Site Plan Review Committee (SPRC)
Staff Report for
4420 Fairfax Drive (The Spire)
SPLA25-00021

4420 Fairfax Drive (SPLA25-00021)
(RPC #14-051-019)

SITE PLAN REVIEW COMMITTEE

DATE: April 23, 2026
PLACE: SPRC Hybrid Meeting #2

Figure 17-- Landscape Plan

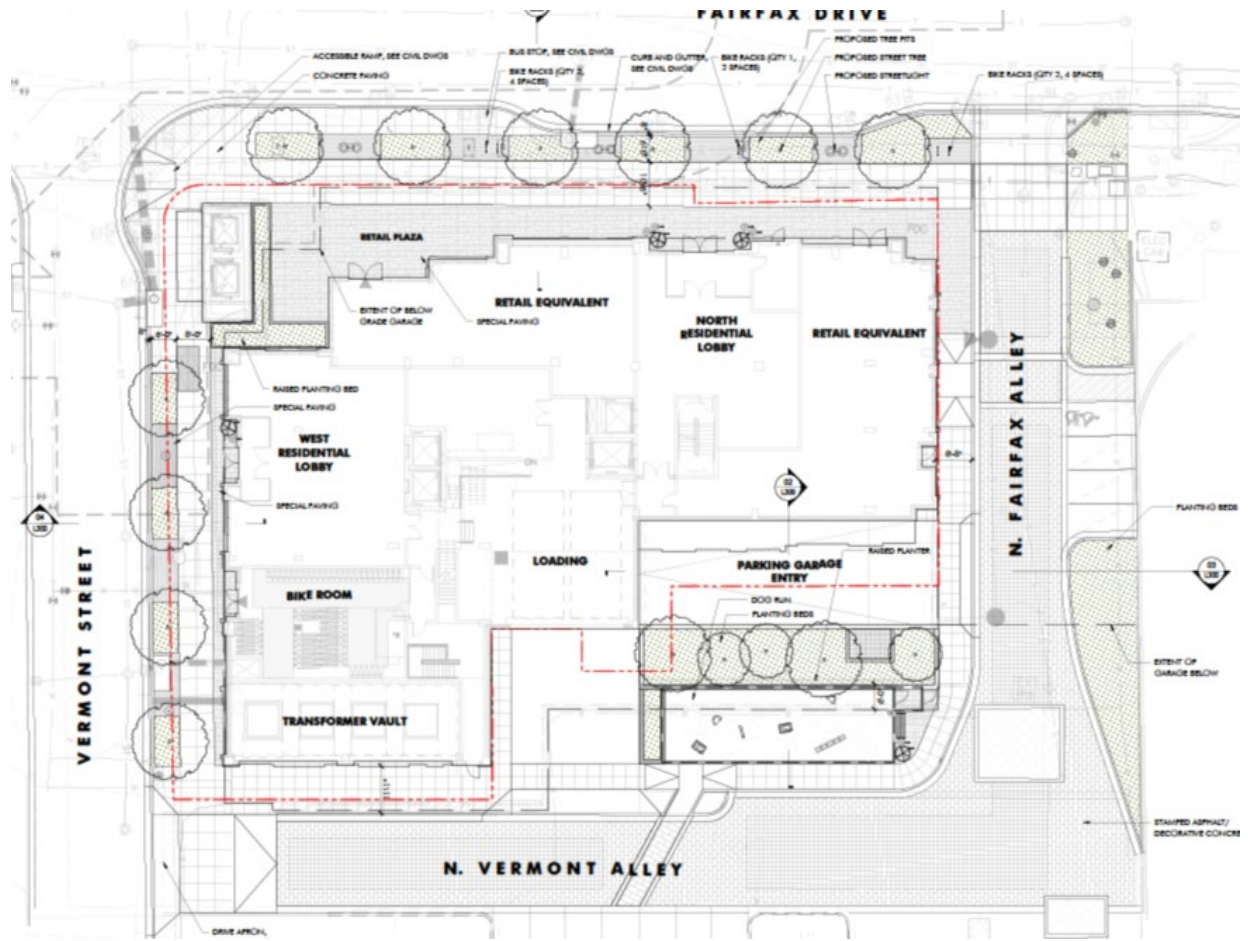
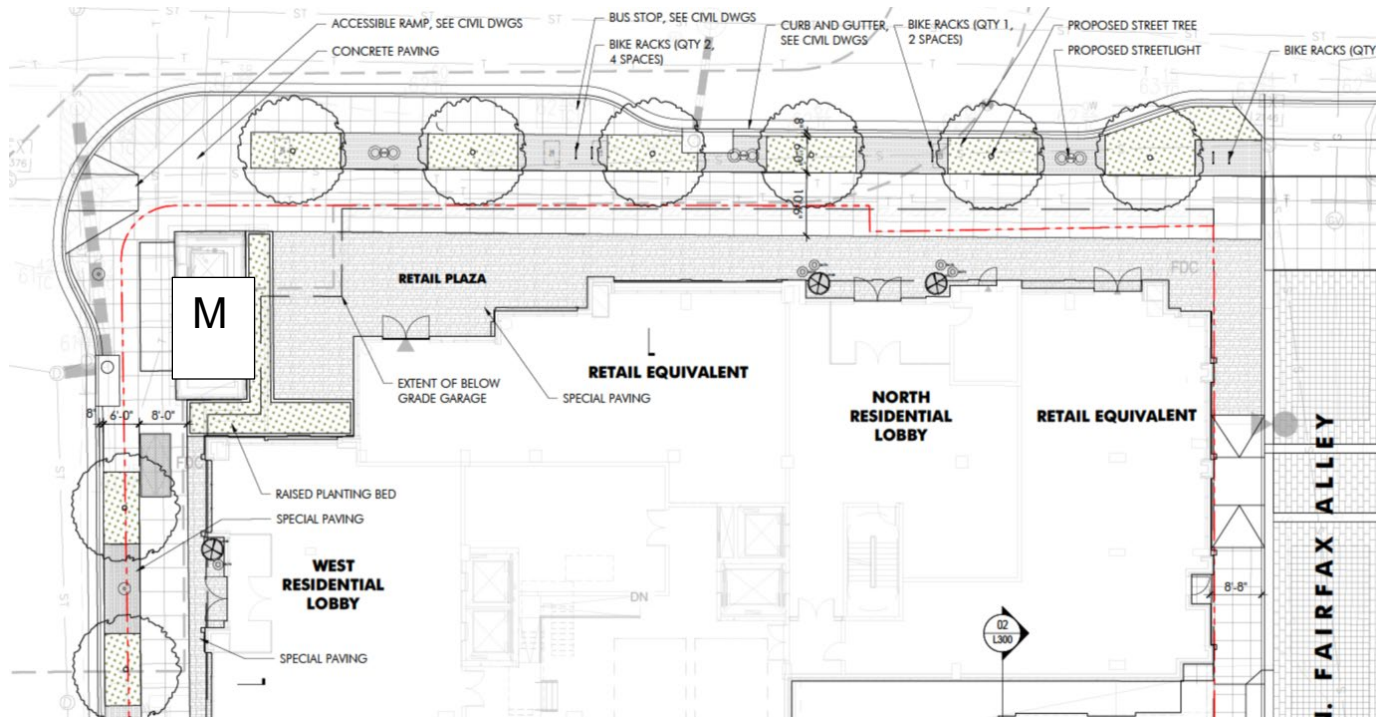
Public Space and Landscaping: The developer proposes a hardscaped public plaza adjacent to the planned Metro Entrance. The Ballston Sector Plan recommends that plazas have “a minimum of one tree per 500 square feet and 150 square feet of grass or groundcover per 1,000 square feet of plaza area.”

Figure 19. Site Access

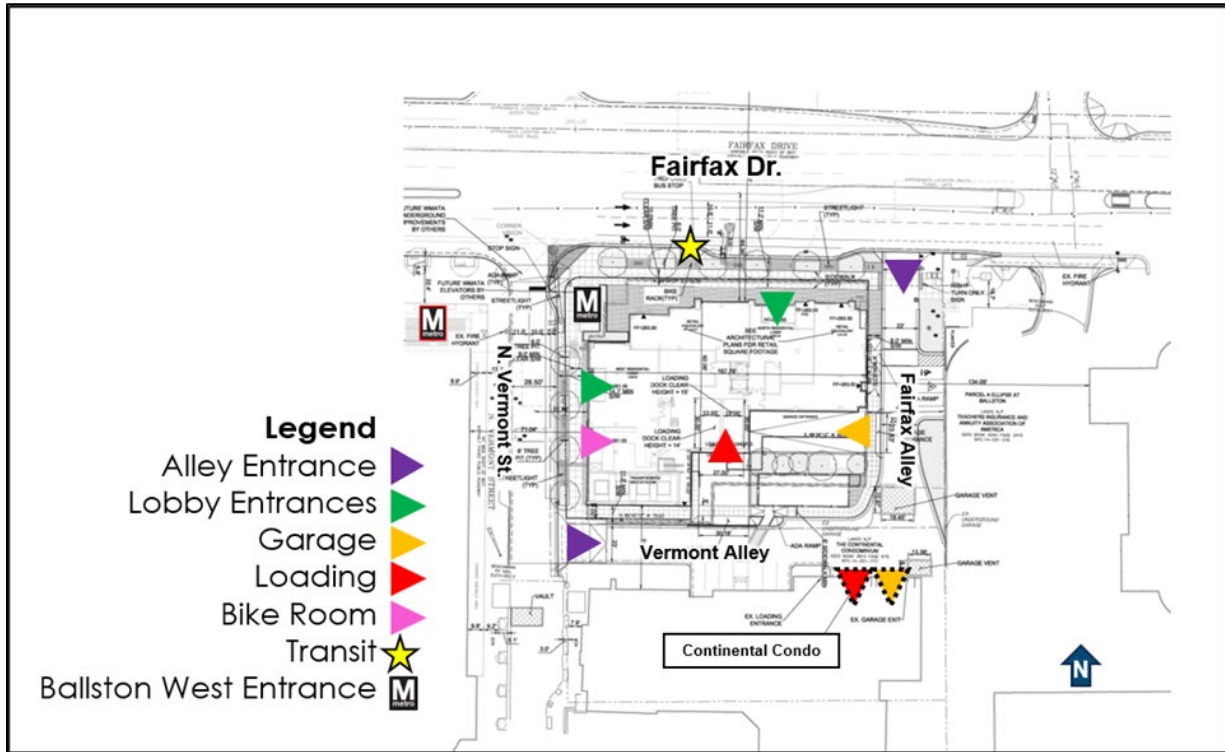
Parking and Loading: The Off-Street Parking Guidelines for Multi-Family Residential Projects Approved by Special Exception in the Rosslyn-Ballston and Richmond Highway Metro Corridors ("Off-Street Parking Guidelines") states that market-rate multi-family projects with proximity to metro entrances provide a minimum of 0.2 vehicle parking spaces per unit, plus 0.05 visitors spaces for the first 200 units. The applicant proposes 128 total vehicle parking spaces located in a below-grade three-level garage. The applicant allocates the parking spaces as 122 spaces for residential at a ratio of 0.40 spaces per unit and 6 spaces for visitors. The garage can be accessed from private offsite driveways from both Fairfax Drive and North Vermont Street (labelled Fairfax Alley and Vermont Alley). The Arlington County Zoning Ordinance exempts retail under 5,000 square feet (sf) from minimum parking requirements. The applicant proposes 4,412 sf of retail and does not require retail parking. The applicant is proposing 4 off-site pull-in surface spaces along Fairfax Alley. The loading space requirement is 3 loading spaces. The applicant is proposing 2 loading spaces, which will be shared between the residential and retail uses. The loading bays will be located along the south side of the building and accessed from Vermont Alley.

Both loading spaces are 30 feet in depth, although the standard site plan conditions require at least one loading space be at least 40 feet in depth.

Figure 21. Proposed Fairfax Drive Cross-Section (Facing East)

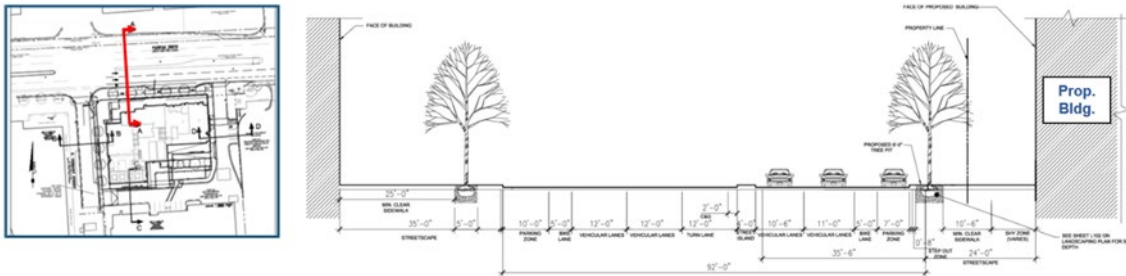
The Rosslyn-Ballston Corridor Streetscape Standards (R-B Corridor Streetscape Standards) identify Fairfax Drive as a “Special Streetscape” by the C-O-A guidelines, which specifies a minimum of 24-foot-wide streetscapes including a 16-foot-wide clear sidewalk and street trees within 5-foot by 12-foot tree pits. The “C-O-A” Streetscape Standards” provide additional guidance on the placement of streetscape elements. The placement guidelines for “Special

The applicant proposes a 24-foot-wide streetscape consisting of a 0.67-foot-wide step out zone, a 6-foot-wide-tree pit, a 10.5-foot-wide clear sidewalk, and a minimum of a 6.8 foot-wide shy zone. The proposed tree pit will be located adjacent to the curb. Double globed streetlights are proposed to be in line with the tree pits. Bike parking is proposed within the furniture zone.

- ~~Landscaping strip on Fairfax Drive interferes with sidewalk width;~~ Clear width of Fairfax Drive sidewalk recommended minimum 16 feet;
- Continue to coordinate with County project for second Ballston Metro entrance;
- ~~Public plaza designs adjacent to Metro entrance; Landscaping encloses proposed public plaza~~
- Longstanding policy and good urban design practice discouraging surface parking in Metro corridors; ~~Removing surface parking on Vermont Alley would provide opportunity for straighter pedestrian pathway on north side, more green space;~~
- Above grade transformers, presence and design;
- ~~Bus stop location.~~
- Depth of at least one loading dock should be 40 feet.
